MILLSTONE NUCLEAR POWER STATION, UNIT NO. 2
AMENDMENT TO FACILITY OPERATING LICENSE

Amendment No.105
License No. DPR-65

ATTACHMENT TO LICENSE AMENDMENT NO.105

RELATED TO AMENDMENT NO. 105 TO DPR-65

FIGURE 3.2-2a AXIAL SHAPE INDEX vs FRACTION OF ALLOWABLE POWER LEVEL per Specification 4.2.1.2c

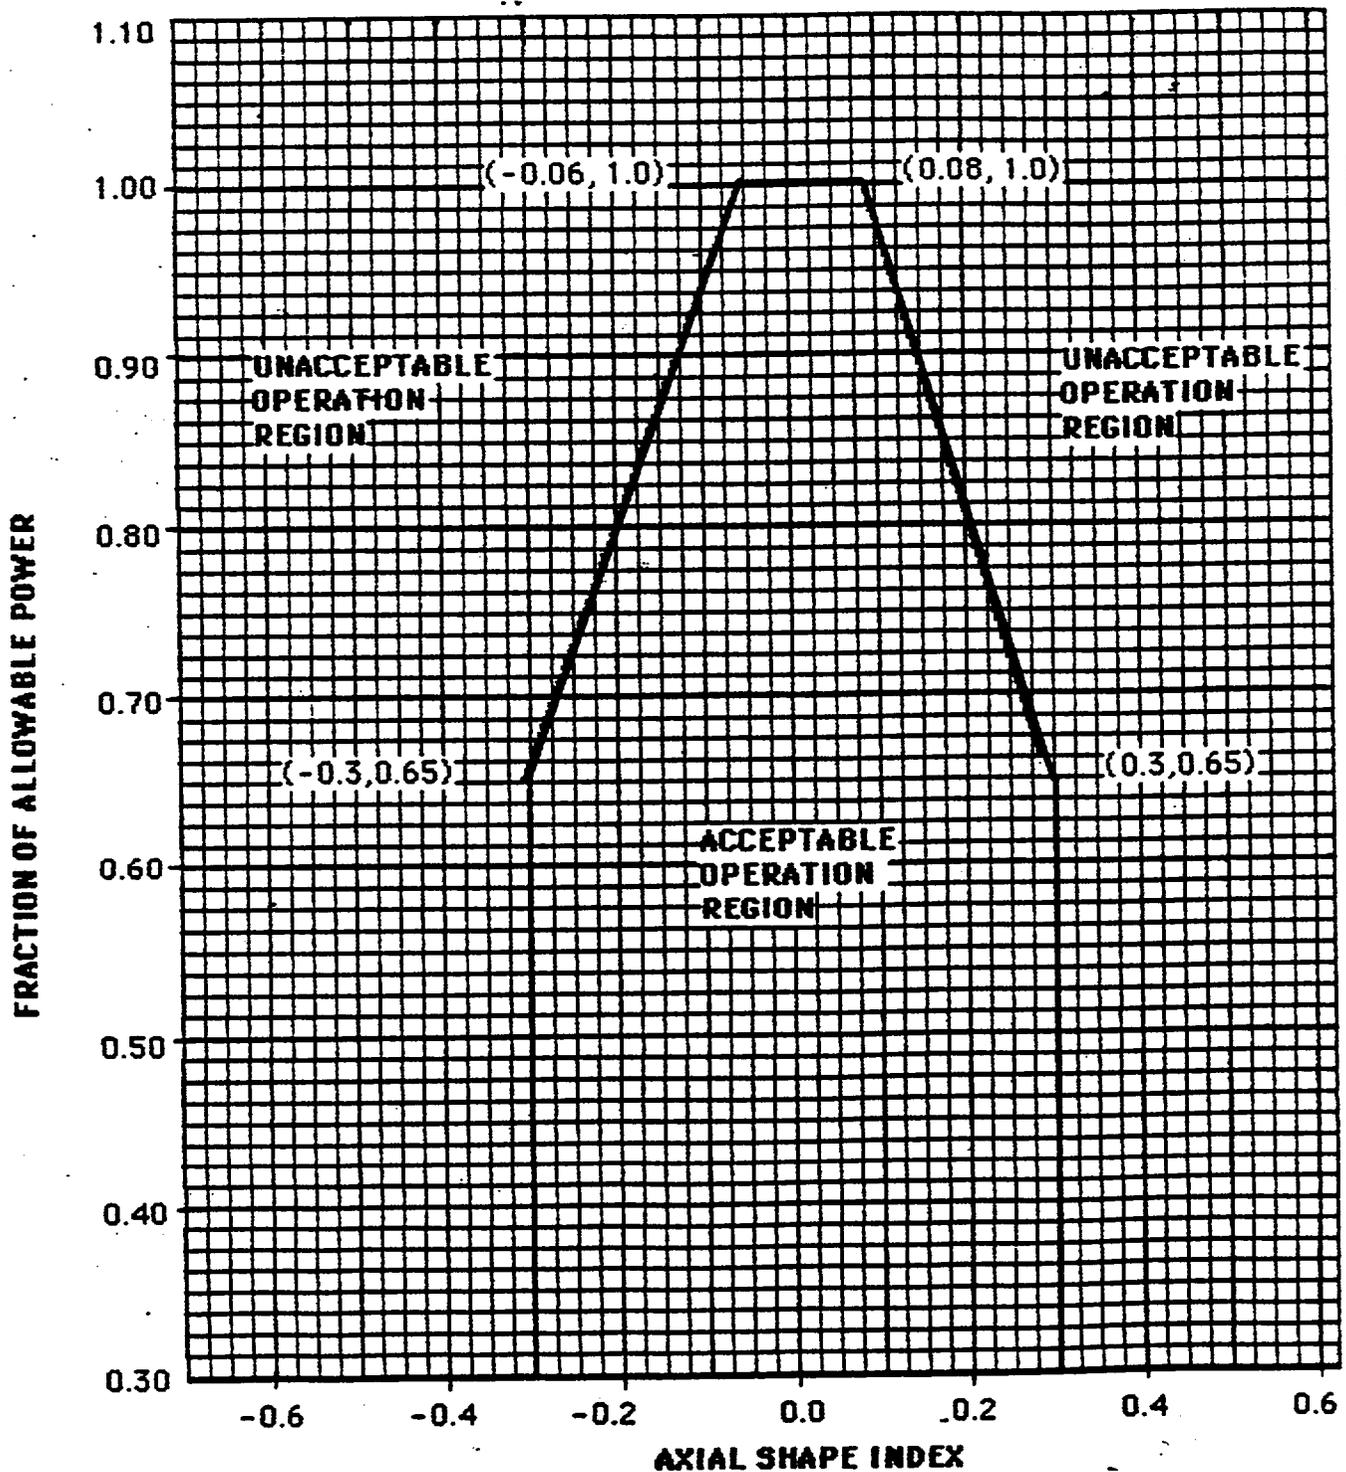
This amendment corrects a typographical error on Figure 3.2-2a of the Technical Specifications.

In Reference 1, Northeast Nuclear Energy Company (NNECo) submitted a license amendment request to correct a typographical error discovered by NNECo during their review of Amendment No. 99 to Facility Operating License No. DPR-65. This error was contained in NNECo's Reference 2 application which was subsequently approved in Amendment No. 99. The error is contained in Figure 3.2-2a which erroneously specified one coordinate as (-0.08,1.0) versus the intended coordinate of (-0.06, 1.0).

Figure 3.2-2a of Amendment No. 99 would have allowed the core power distribution to operate in an unacceptable region. Prior to startup from the Cycle 7 refueling and maintenance outage, NNECo discovered the error and took administrative action to limit operation to the proper co-ordinate. Operation within the unacceptable region did not occur.

This amendment corrects the error and does not impact the previously derived maximum linear heat rate or any other parameter which could adversely impact plant transient or accident analysis. References 2 & 3 remain applicable to this change and support the conclusion that none of the criteria of 10 CFR 50.59(a)(2) are compromised. There has been no error in the analysis or methodology used to determine the curve, rather the error is administrative. Typographical errors in the NNECo Technical Specifications are rare and there is no evidence of pervasive errors of this nature so remedial action is not recommended. Based on the above discussion, we find the proposed change to the Technical Specification acceptable and necessary.
